For PCB Power supply unit (6321 856.002) a modified PCB SMPS (6321 895.008) is available.

PCB SMPS 6321 895.008
on PCB Power supply
6321 856.002

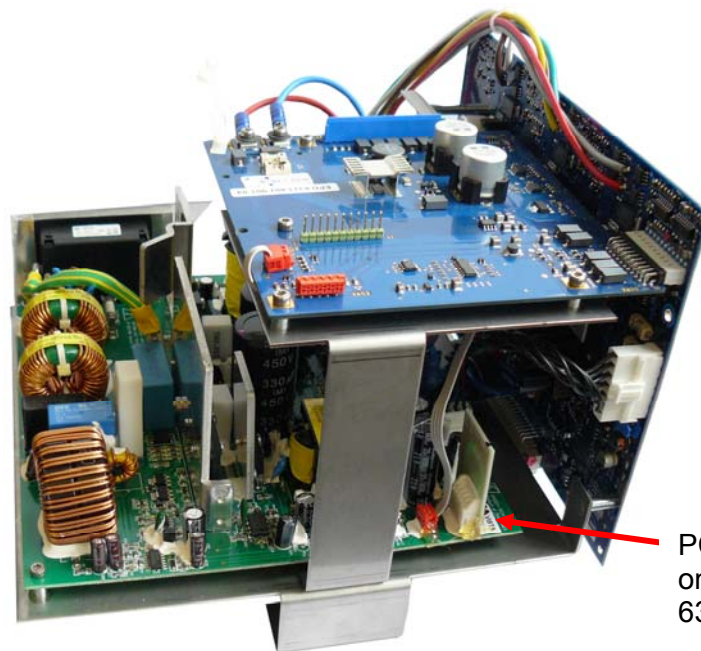
For Mastercycler pro with PCB Power supply 6321 856.002 the PCB SMPS (switch mode power supply) must be exchanged, if the errors D2C and/or D2D occasionally occur.

For Mastercycler ep 5341 / 5344 / 5345 and Mastercycler realplex 6300 / 6302 the previous PCB Power supply 6321 856.002 as well as the PCB Power supply 5341 856.002 are further on usable without any modifications.
